CHANGE NOTIFICATION

PCN# 011316

Subject: Notification of Additional Assembly Location, ASE Korea for LTM4618

Top Mark

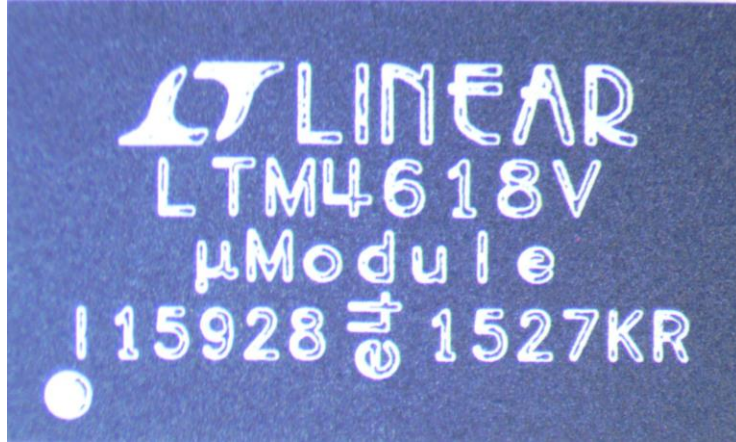
Please be advised that Linear Technology Corporation has successfully qualified ASE Korea as an assembly site for the subject packages. It was desirable to qualify ASE Korea to serve as an alternate source since it is located in a different geographic area than our existing assembly location in Penang, Malaysia. ASE Korea is ISO9002, QS9000, ISO14001, TS16949, OHSAS 18001 and QC80000 certified. A summary of ASE Korea's product mix and LTC's qualification results are shown on the attached pages. The facility passed a site audit by LTC's supplier quality organization. LTC product assembled in ASE Korea can be identified by the country of origin marked on the device as "KR". The Approximate datecode of the first units assembled by ASE Korea, and the list of affected part numbers is presented below in the table.
